City of Bellevue Development Services Department Land Use Staff Report

Proposal Name: Newport Hills Neighborhood Park

Proposal Description: Critical Areas Land Use Permit to develop a new

File Number: 20-114187-LO

PLANT SCHEDULE

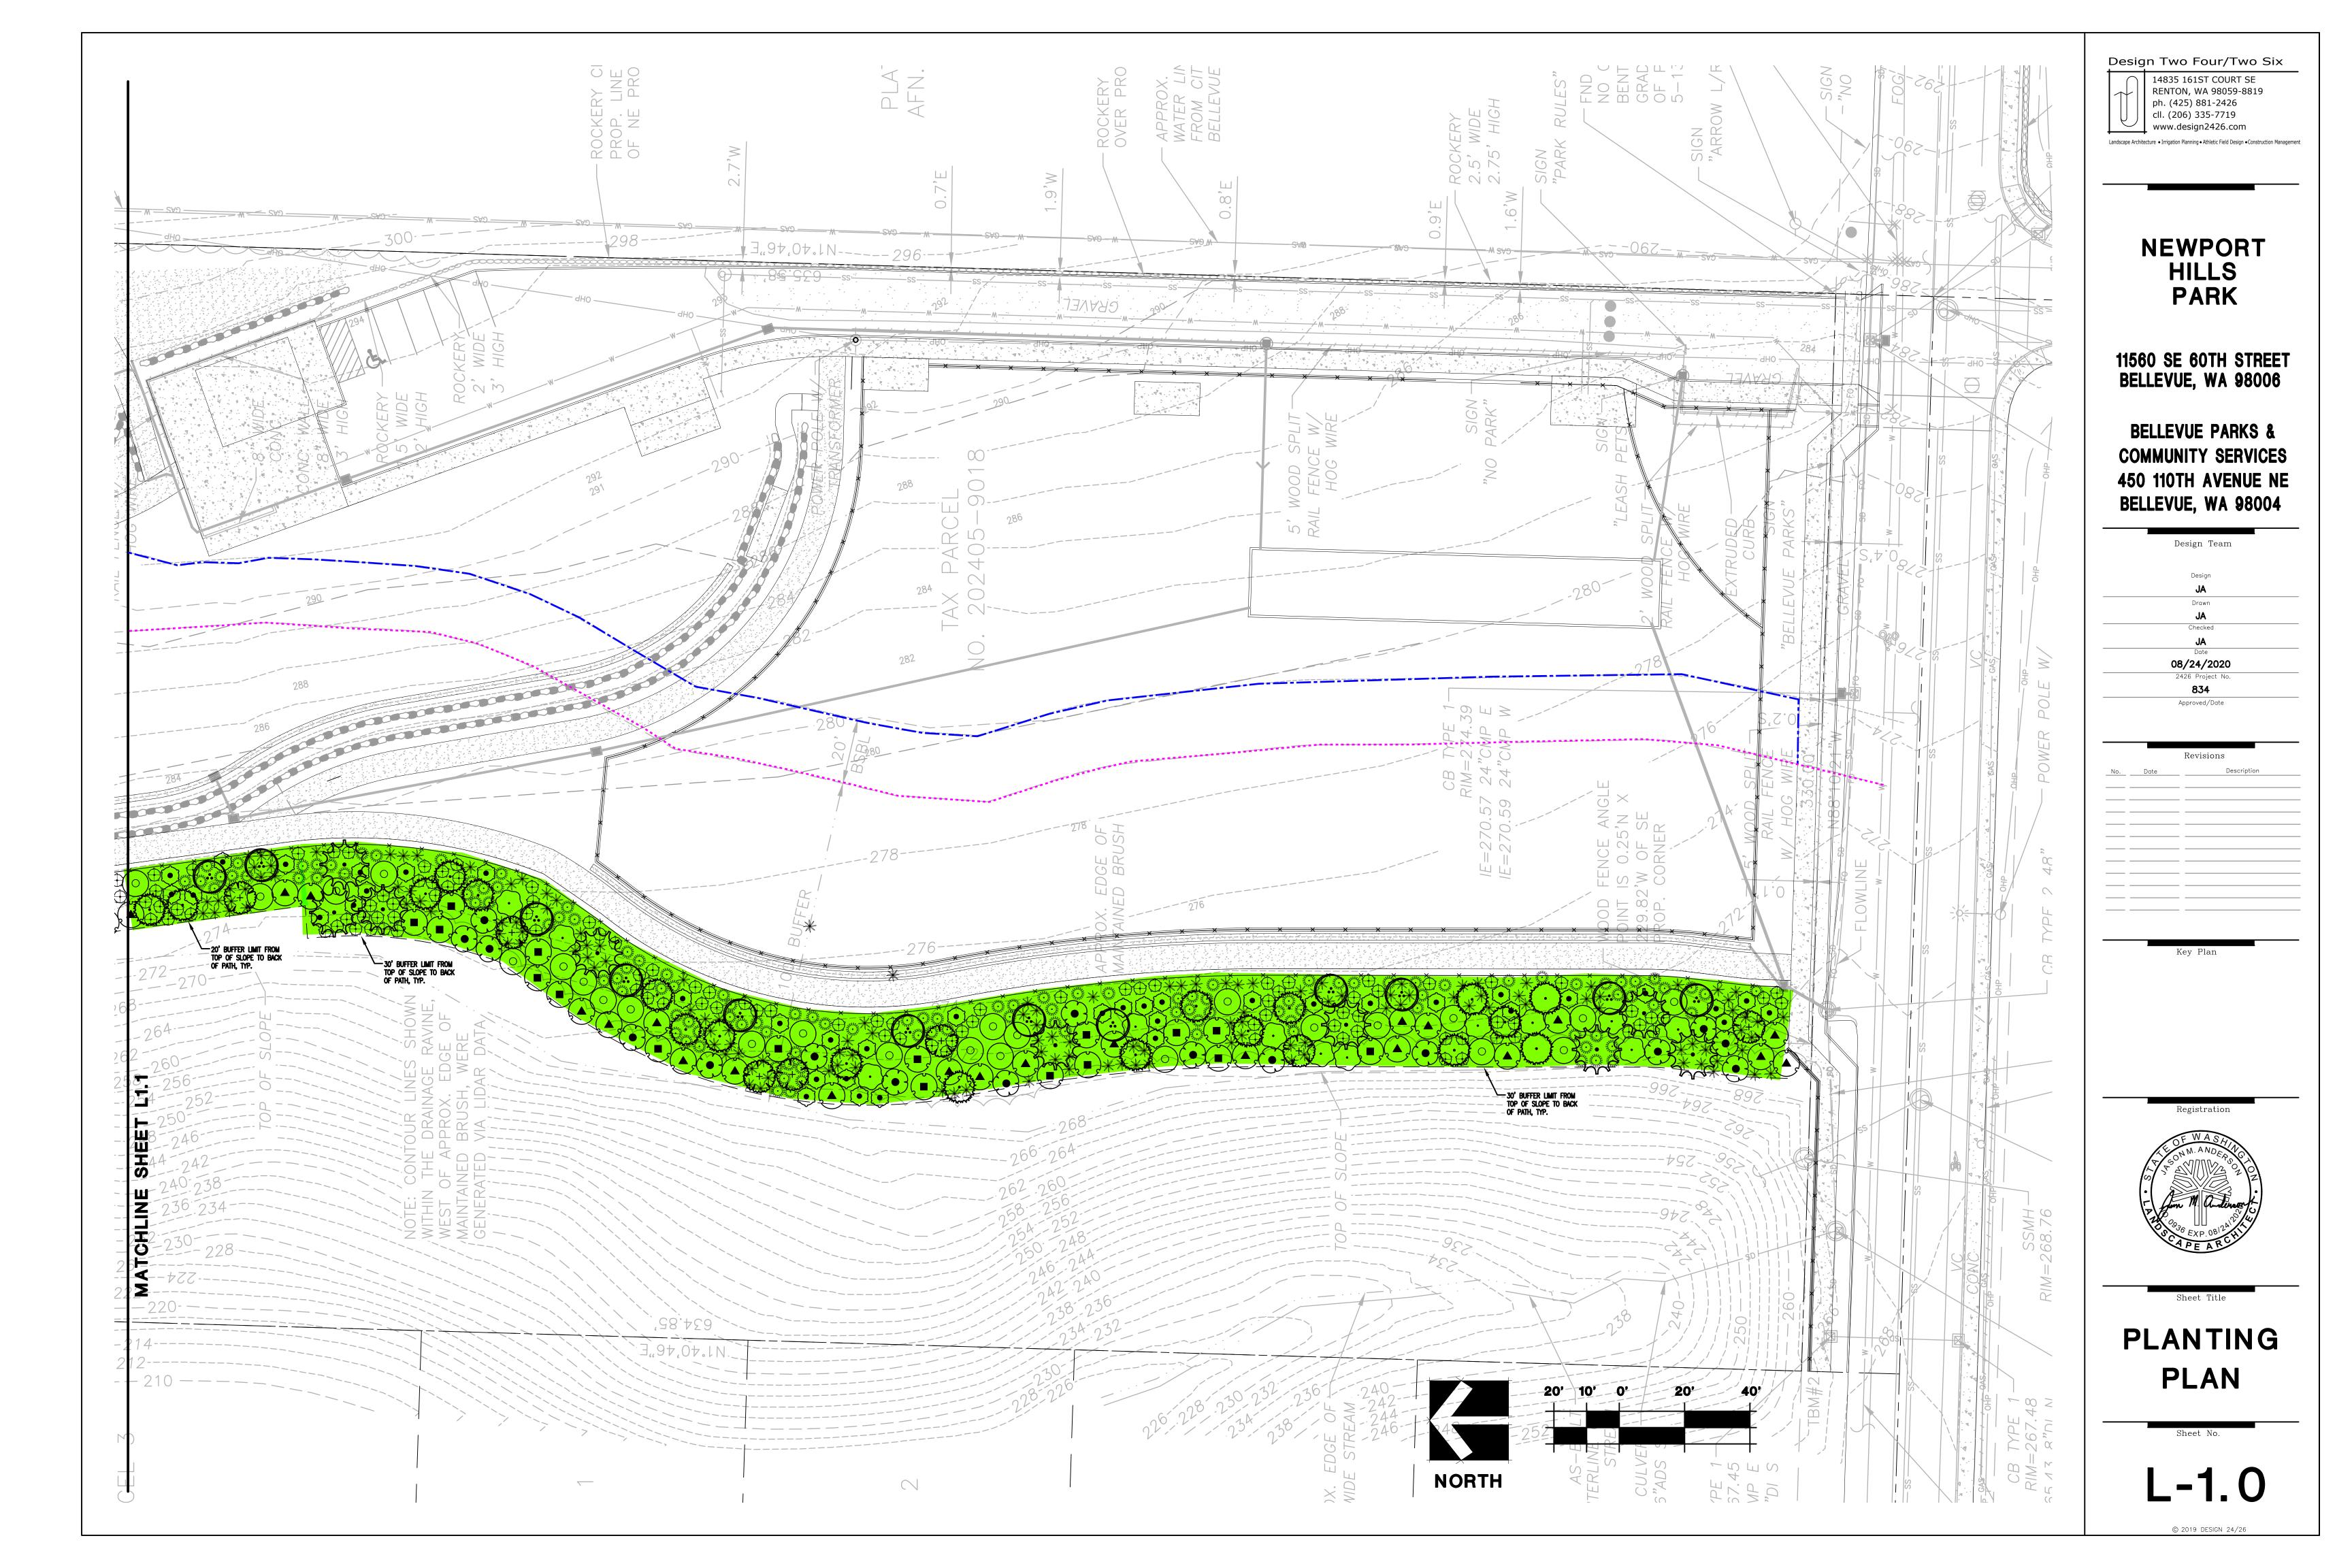
Provide a symbol for the existing trees within this area. This will assist with the placement of additional trees.

Utilize the attached critical areas handbook for information on distances between trees and species suggestions.

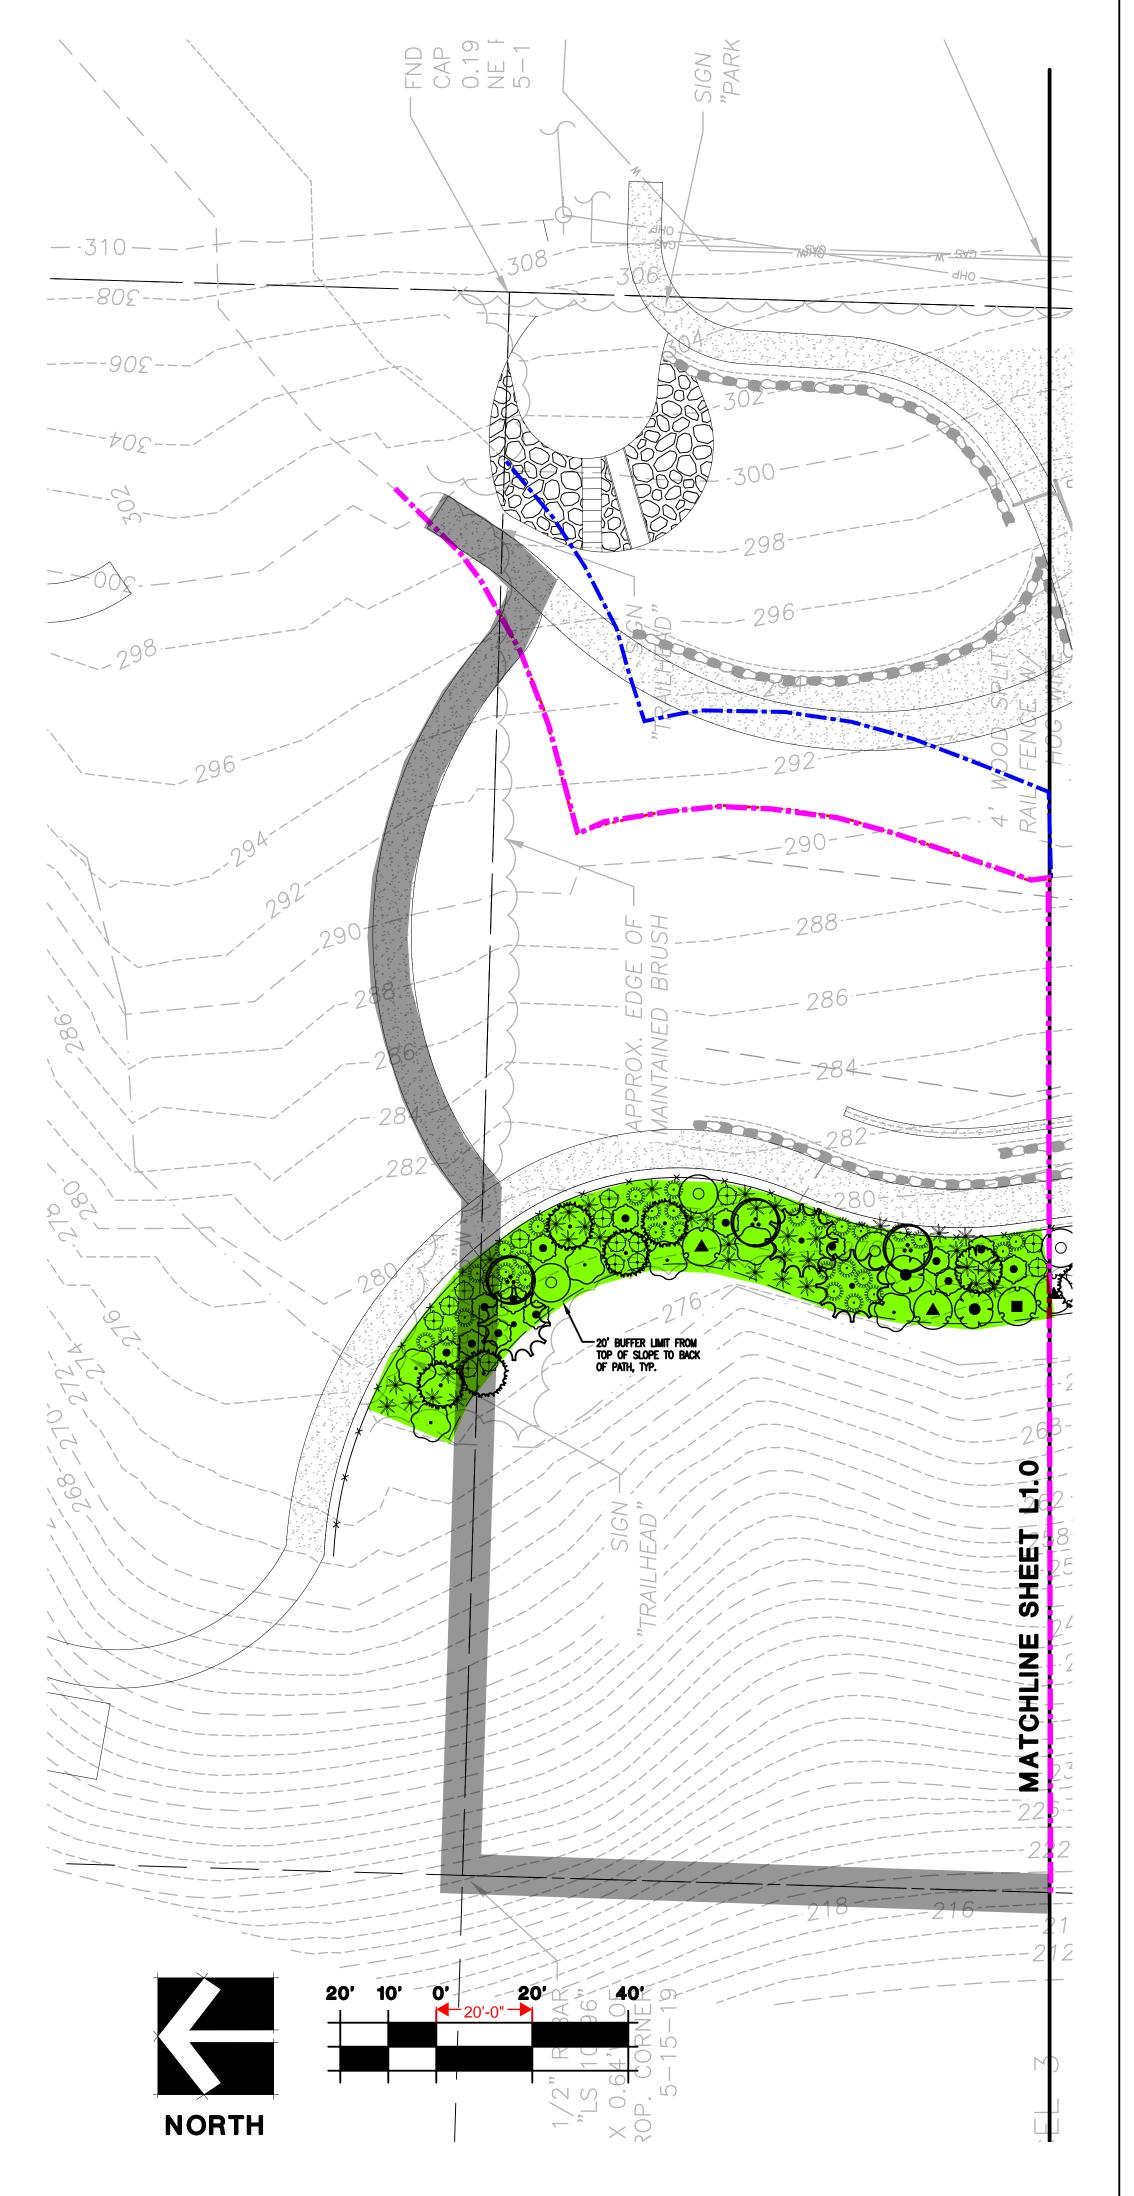
The species shown above are native. Verification will be needed as to whether they will thrive in the understory of the existing trees. Site does have good southern light, North side of lot is wetter, and may need different species that will tolerate more moist soils.
